July 19, 2010

Prepared by:  
KBA Architects  
Knight, Bagge & Anderson, Inc.  
6 Thirteenth Street  
Charlestown, MA 02129  
Tel 617-241-2807 Fax 617-241-2857

### **ADDENDUM NO. 1**

WINDOW REPLACEMENT TO THE  
BURR ELEMENTARY SCHOOL

**SILL DETAIL**  
(MODIFIES DETAILS 4/A2.1,  
22/A2.1 & 23/A2.1)

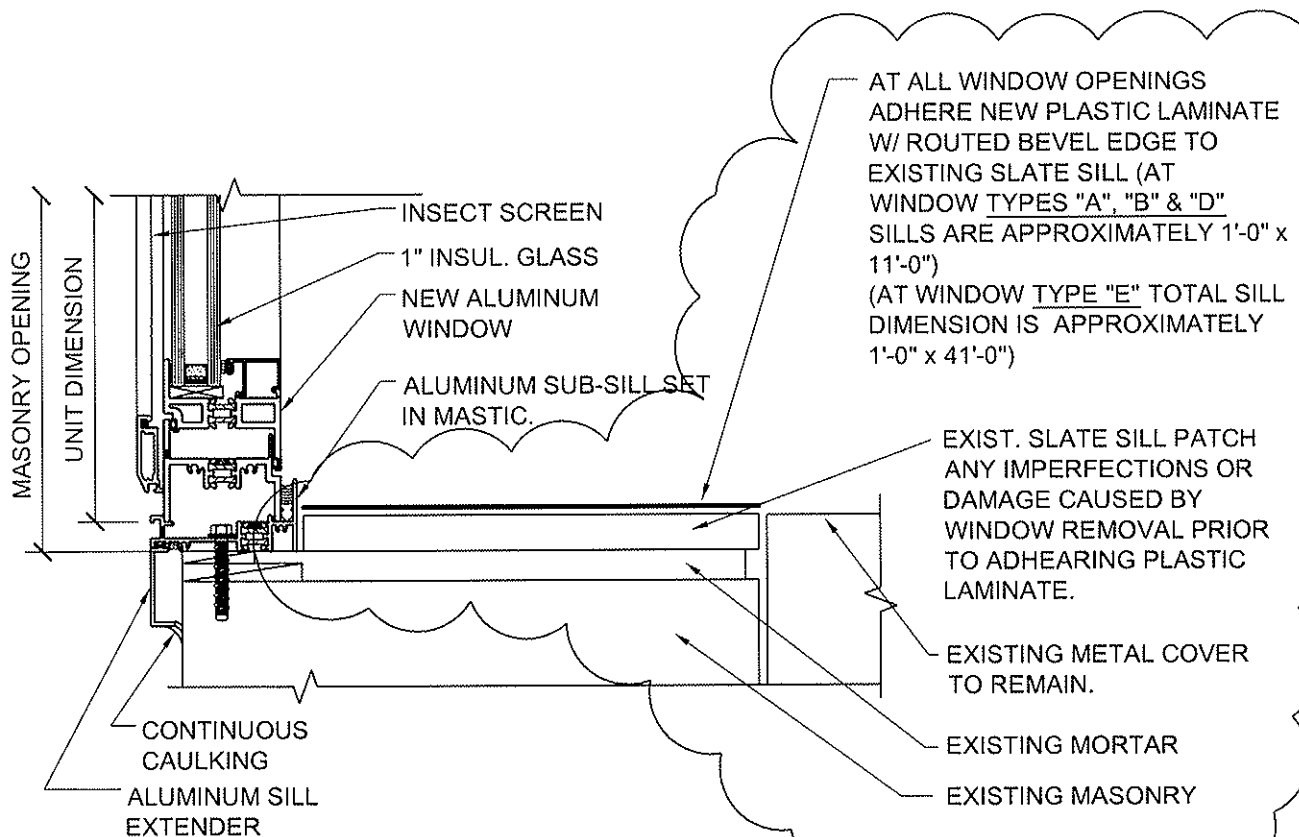
Item No. 1: Drawing A2.1: Delete detail 4/A2.1 in its entirety and insert Detail 4/A2.1 revised which is on SKA-1 attached to this addendum.

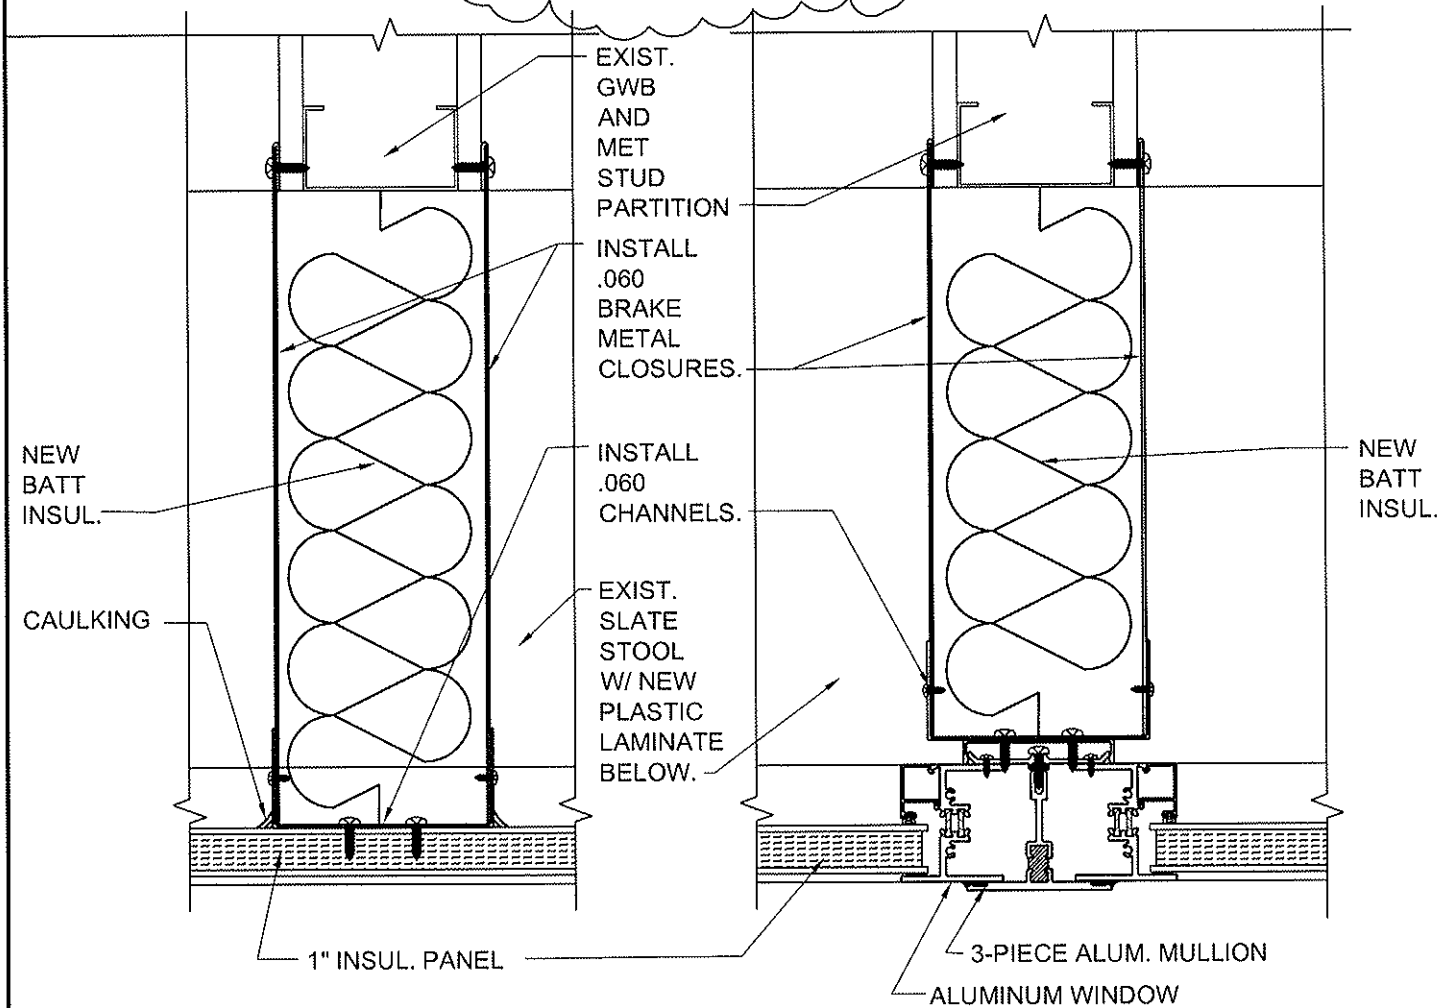
Item No. 2: Drawing A2.1: Insert details A/SKA2 and B/SKA2 found on SKA-2 which is attached to this addendum. These sketches clarify the detail of closing off the partitions to the window wall at window Type E.
